## Town of Franklin

**DATE:** May 7, 2020  
**TO:** Franklin Planning Board  
**FROM:** Department of Planning and Community Development  
**RE:** 158 Grove Street  
Special Permit & Site Plan Modification

# SITE PLAN MODIFICATION 70, 72, 88 AND 94 EAST CENTRAL STREET

**Re: 70, 72, and 94 East Central Street  
Site Plan Peer Review Update**

SITE PLAN MODIFICATION  
CONSTRUCTION DETAIL PLAN - 2  
70, 72, 88 AND 94 EAST CENTRAL STREET  
FRANKLIN, MASSACHUSETTS  
PREPARED FOR  
70 EAST CENTRAL STREET, LLC  
37 EAST CENTRAL STREET  
FRANKLIN, MASSACHUSETTS  
MARCH 4, 2020  
SCALE: 1" = 20'

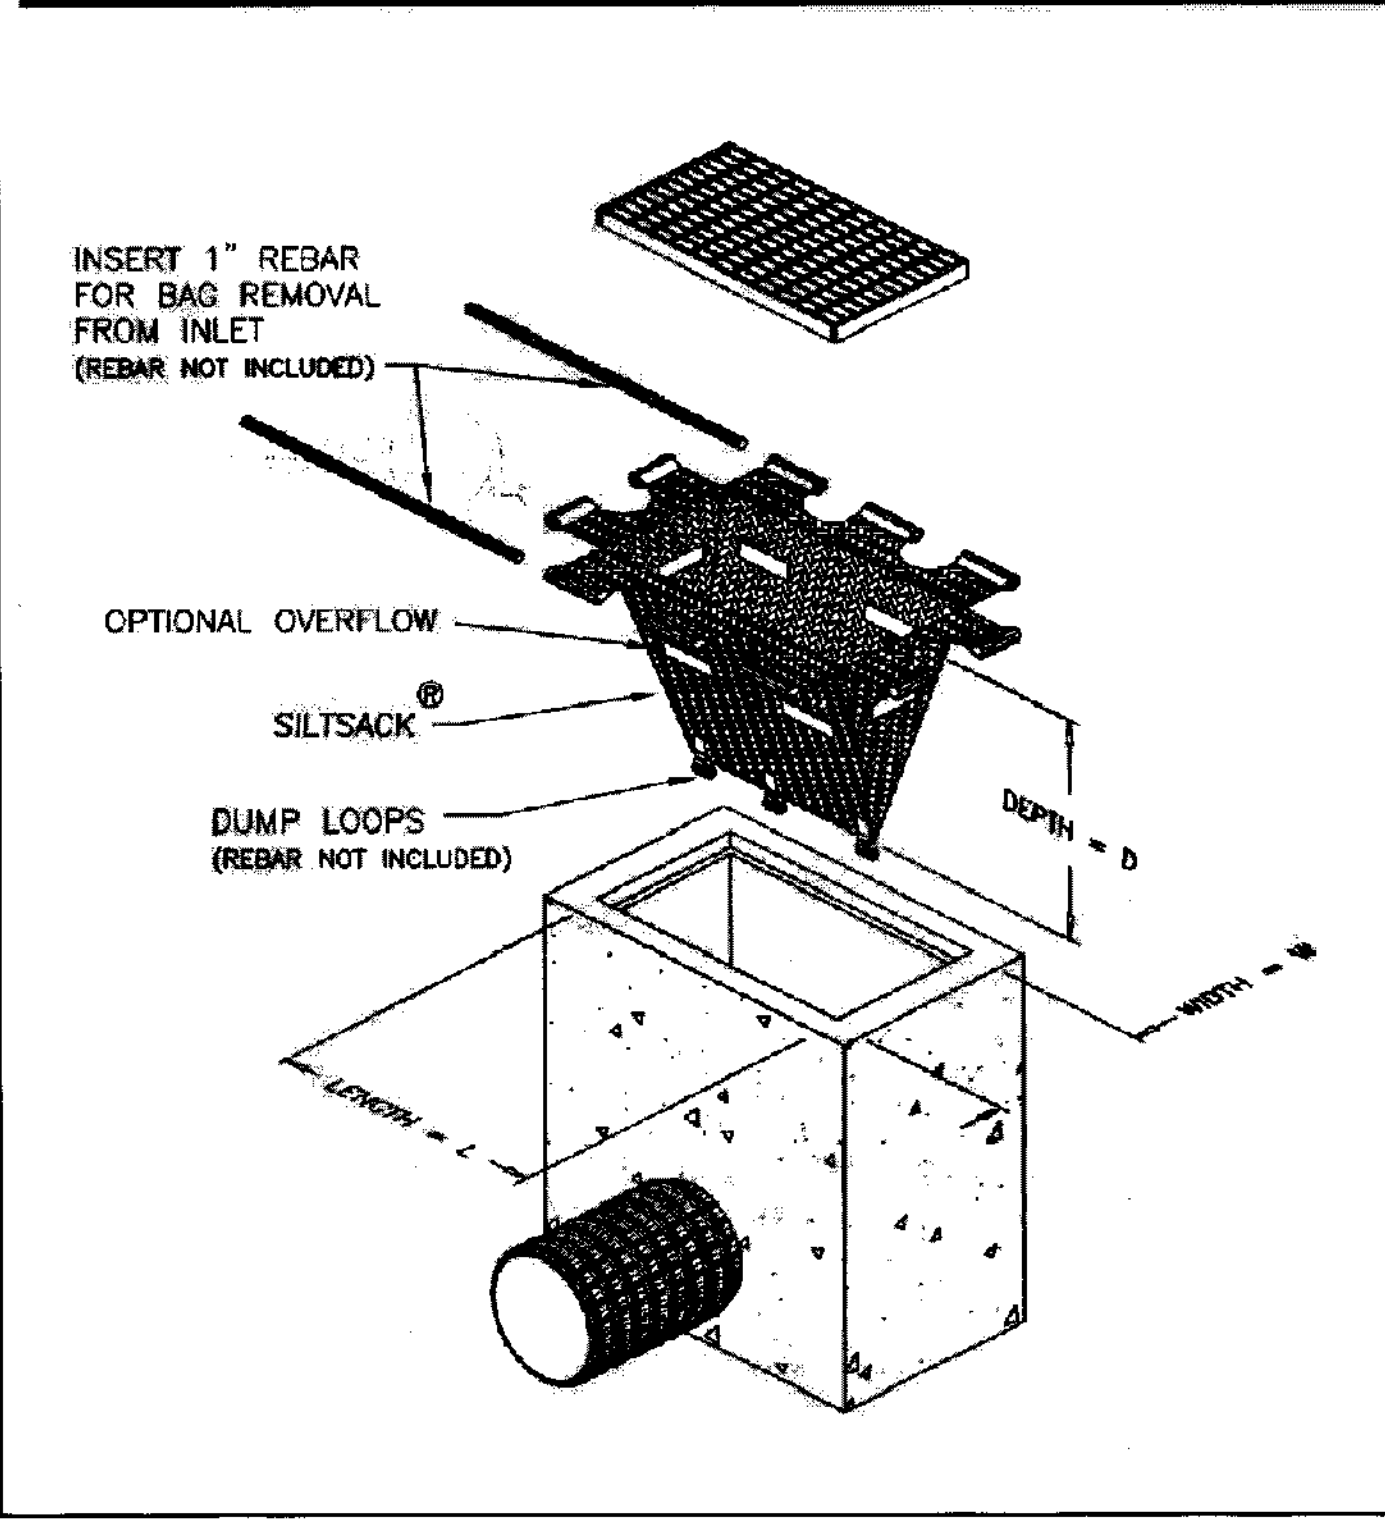
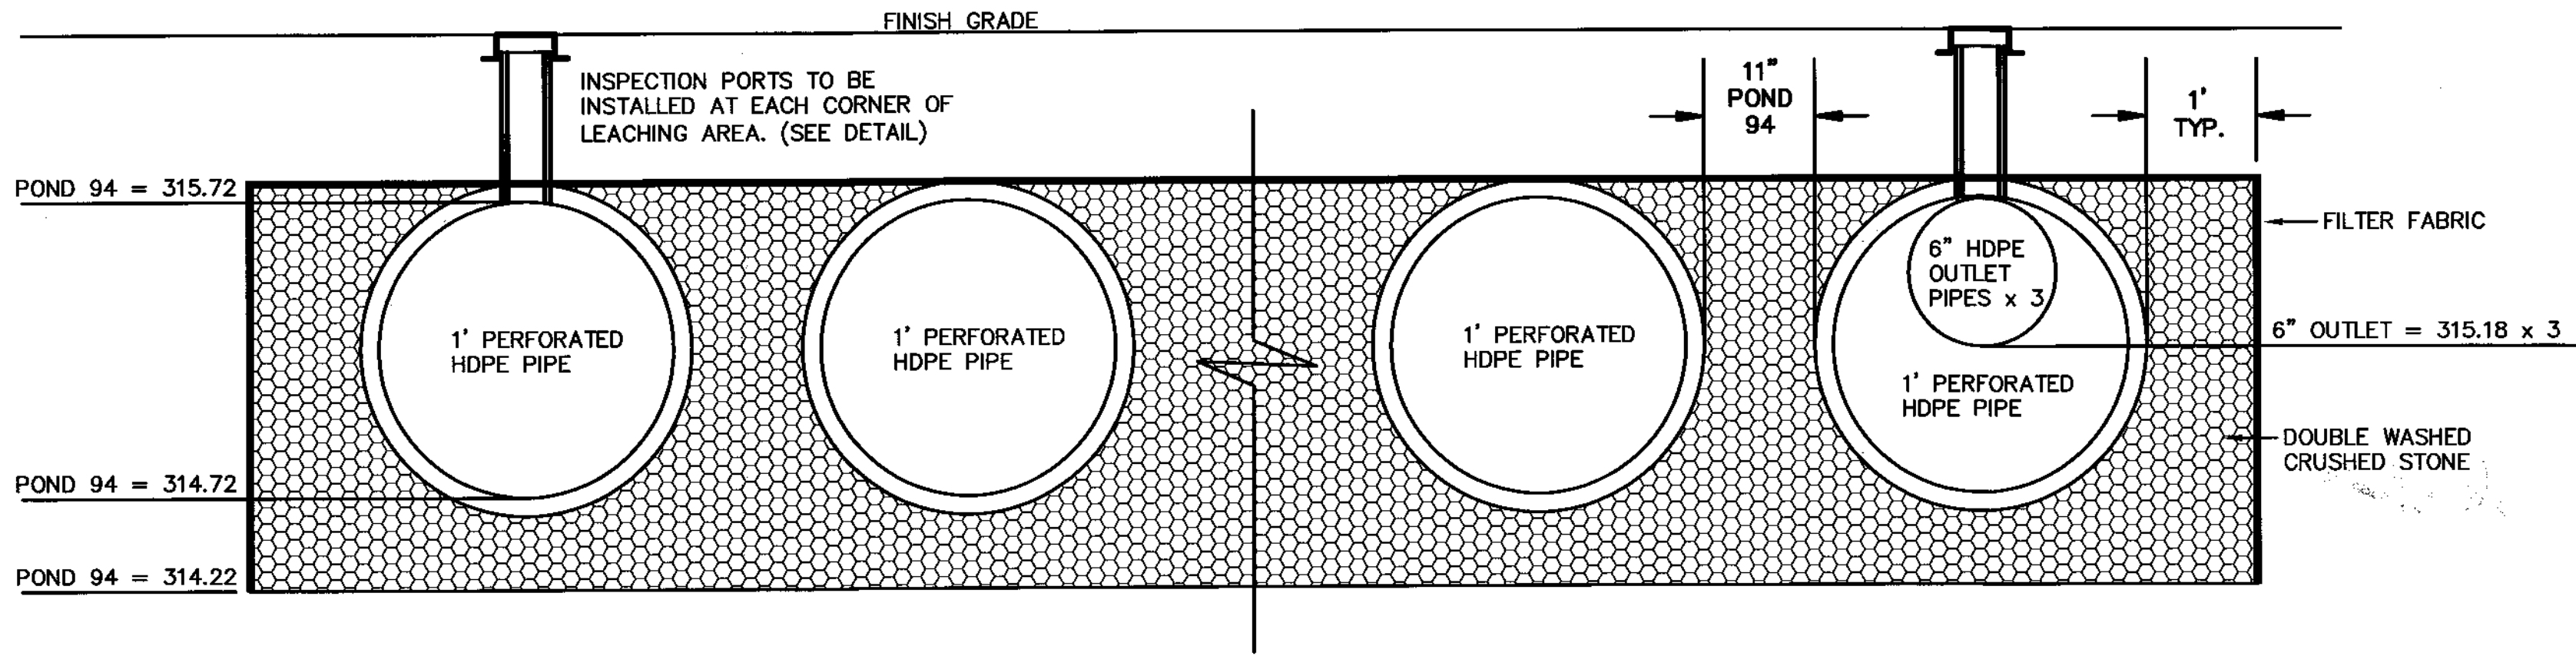
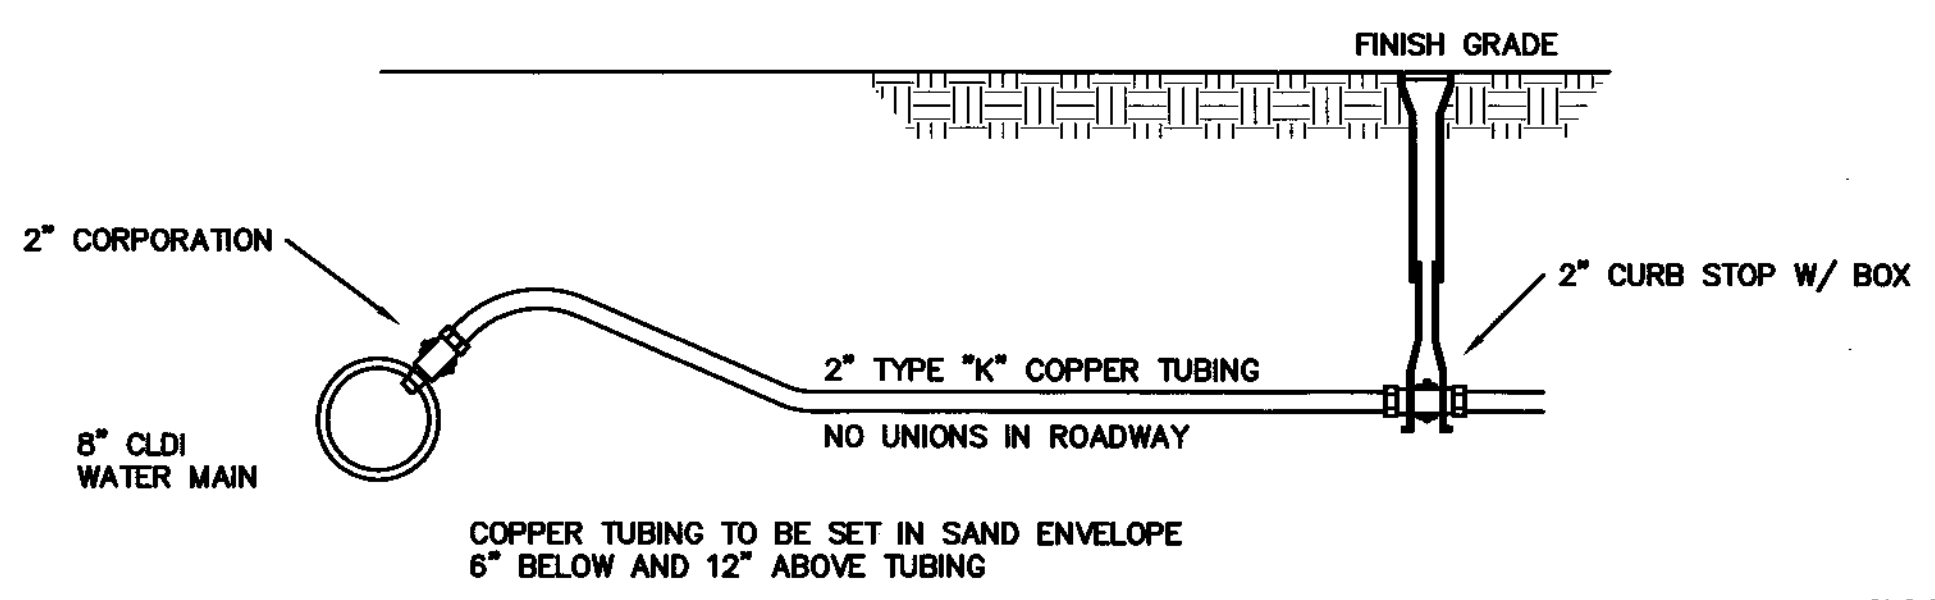
SW10. Revise notes on Drainage Infiltration Area detail to reference dimensions and quantities associated with Pond 94. *UCI: The notes for the drainage Infiltration Area have been revised on sheet 8.* **BETA2: Note revised – issue resolved.**

SW11. Provide a detail or relevant notes on the plan to identify the invert elevations of the infiltration basin outlet manifold. *UCI: The outlet pipes were added to the drainage infiltration area detail on sheet 8.* **BETA2: Detail revised – issue resolved.**
